# Service Bulletin

CRF1100A/A4/D/D4 #1  
Revised November 2023

### 2020 ~ 2022 CRF1100A/A4/D/D4 AFRICA TWIN MULTI-INFORMATION DISPLAY TOUCHSCREEN

**REPAIR IDENTIFICATION**

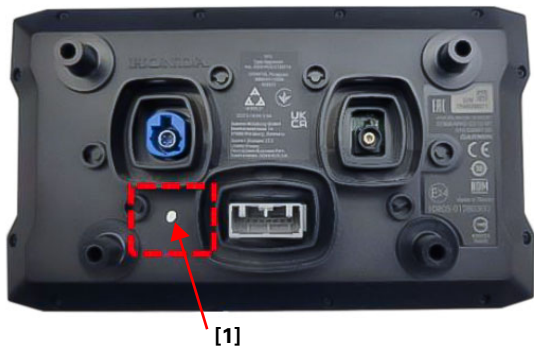
A countermeasured multi-information display can be identified by a white permanent paint mark [1] on the back of the display, as shown.
